9 Twin Orchard Drive
Oswego, NY 13126
December 5, 2002

Mr. John A. Grobe, Director
Division of Reactor Safety
US Nuclear Regulatory Commission
801 Warrenville Road
Lisle, IL 60532-4351

Could I talk to you about the lower head deposits? Originally the Incore tubes had a problem. I am thinking that if the problem was vibration, perhaps they moved as I have shown in my Sketch 1. This would present a possible fatigue problem at (or near) the weld fastening them to the reactor vessel lower head.

Sketch 2

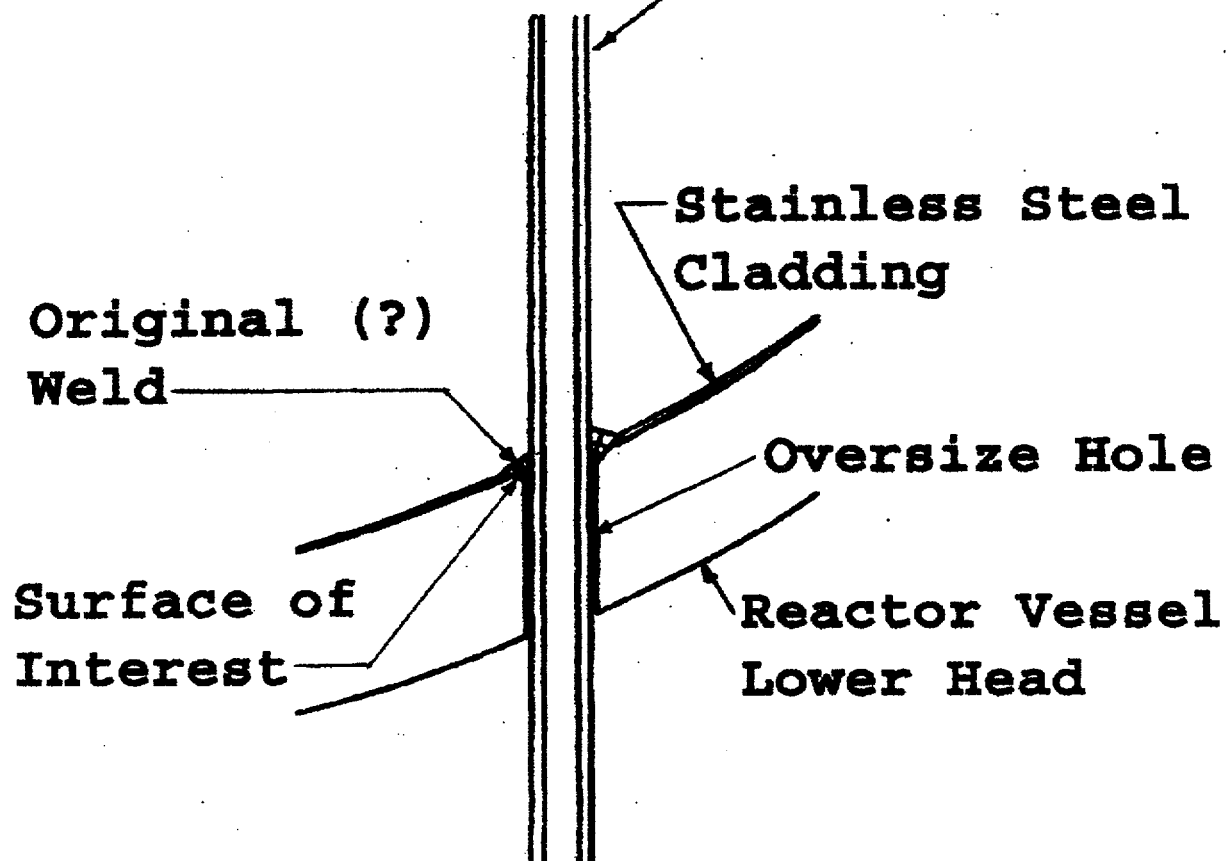
If the stainless steel cladding on the Davis-Besse reactor vessel lower head was put on a "battered" layer of another weld metal that was first welded to the carbon steel reactor vessel, there would be some challenging weld metal selection decisions needed for what I

have labeled the "Surface of Interest" on my Sketch 2. Note that it continues all around the Incore tube.

If there has been leakage of reactor coolant at my "Surface of Interest," it appears that it will drain away since there is no interference fit of the original Incore tube. However, if the Contingency Repair is made, this will no longer be the case. The weld(s) at the bottom of the head will pool any coolant just above them. Also, the severed tube will allow further leakage into the Incore tube, where, I guess, it would attack the Incore monitoring wires.
